Piper Aircraft Corporation

SUBJECT: Replacement of 1/8 - 7 x 19 Flexible Stainless Steel Control Cables

SERVICE BULLETIN № 181

PA-18

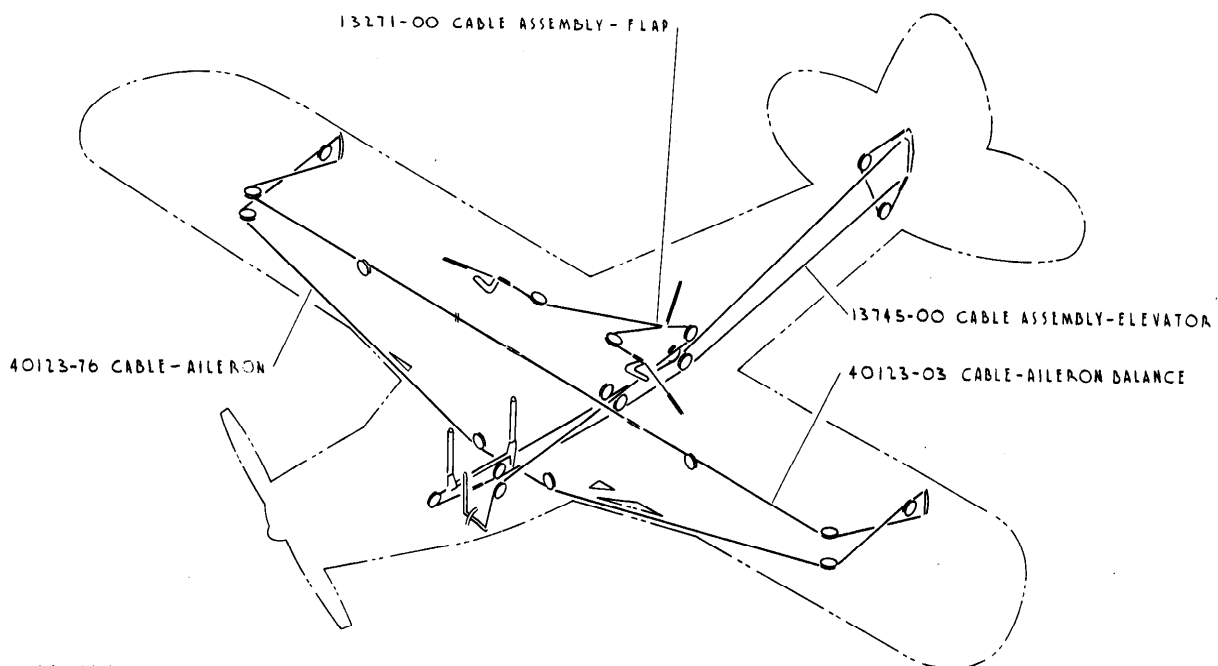
The following is a list of the affected control cables and their respective replacement parts which apply to the aircraft serial numbers listed after "MODELS AFFECTED", exclusive of the aircraft listed under Note "A". See sketches A, B and C for identification.

Replace Stainless Steel Cables			Install Replacement Cables		Aircraft Application	
Part No.	Qty. Req.	Nomenclature	Part No.	PA-18	PA-18A	
12794-03	1	Cable - Flap	12794-00	X		
13271-02	1	Cable - Flap	13271-00			X
13745-02	1	Cable - Elevator, lower	13745-00	X		X
40123-44	2	Cable - Aileron	40123-03	X		X
40123-86	2	Cable - Flap	40123-77	X		
40123-87	2	Cable - Aileron	40123-76	X		X
